SIB 17 01 22

SERVICE ACTION: INSPECT AND MODIFY OPTIONAL ACCESSORY
COOLER GUARD

Model	Model Description	Model Year
K66	M 1000 RR	2021 – Current
K67	S 1000 RR	2020 – Current

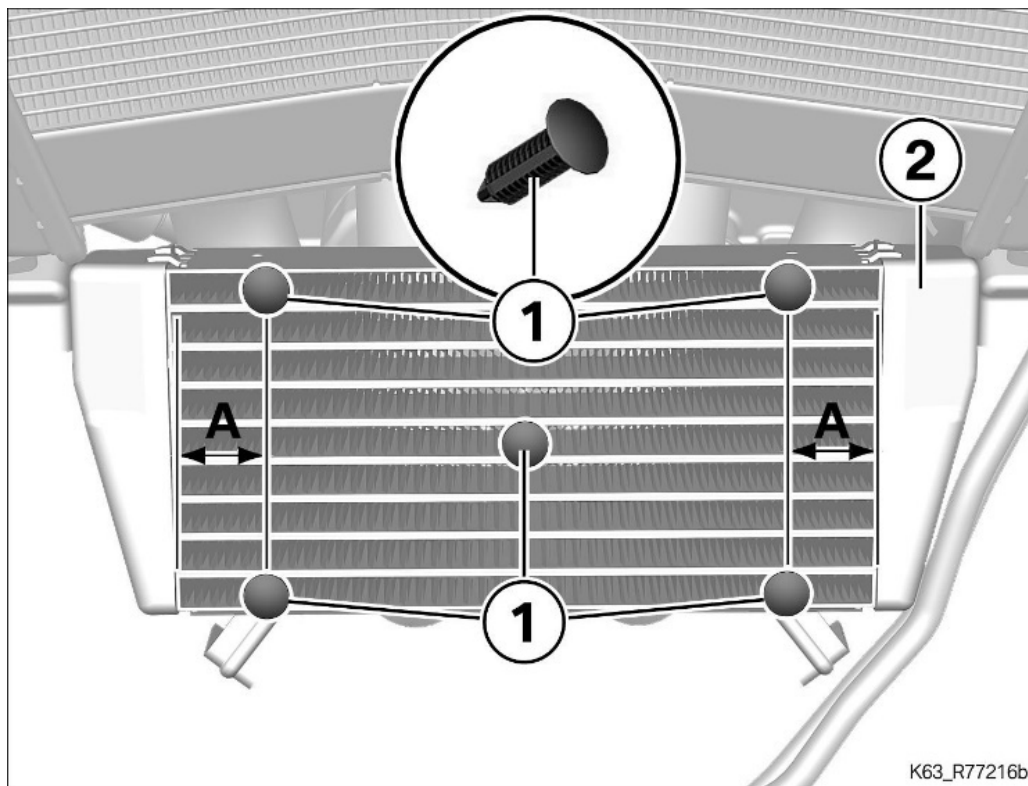
Installation of the accessory oil cooler guard from the BMW Motorrad Special Accessories Catalog may result in chafe marks on the cooler.

New installation instructions require use of special spacers to prevent chafing marks on the oil cooler.

If the accessory oil cooler guard is installed, please reinstall it with five (5) spacers, part number below. Follow instructions "77 14 006 – Installing the radiator protection" in AIR, which were updated in February 2022.

Once the oil cooler guard is re-installed with spacers, please confirm that the guard is not touching the oil cooler.

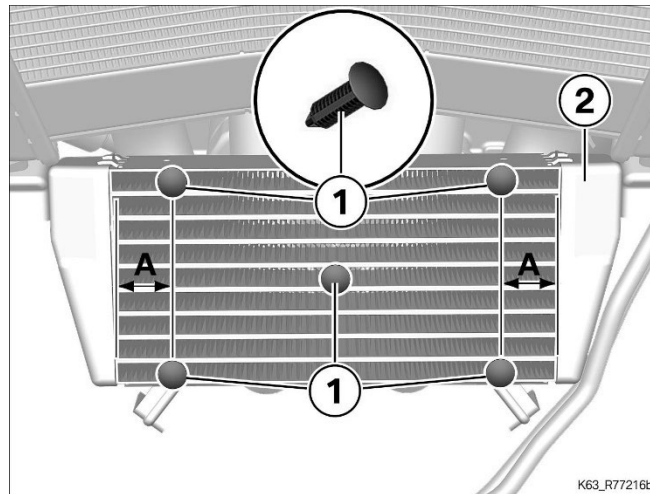
Installation of the accessory oil cooler guard from the BMW Motorrad Special Accessories Catalog may result in chafe marks on the cooler.

New installation instructions require use of special spacers to prevent chafing marks on the oil cooler.

If the accessory oil cooler guard is installed, please reinstall it with five (5) spacers, part number below. Follow instructions “77 14 006 – Installing the radiator protection” in AIR, which were updated in February 2022.

Once the oil cooler guard is re-installed with spacers, please confirm that the guard is not touching the oil cooler.
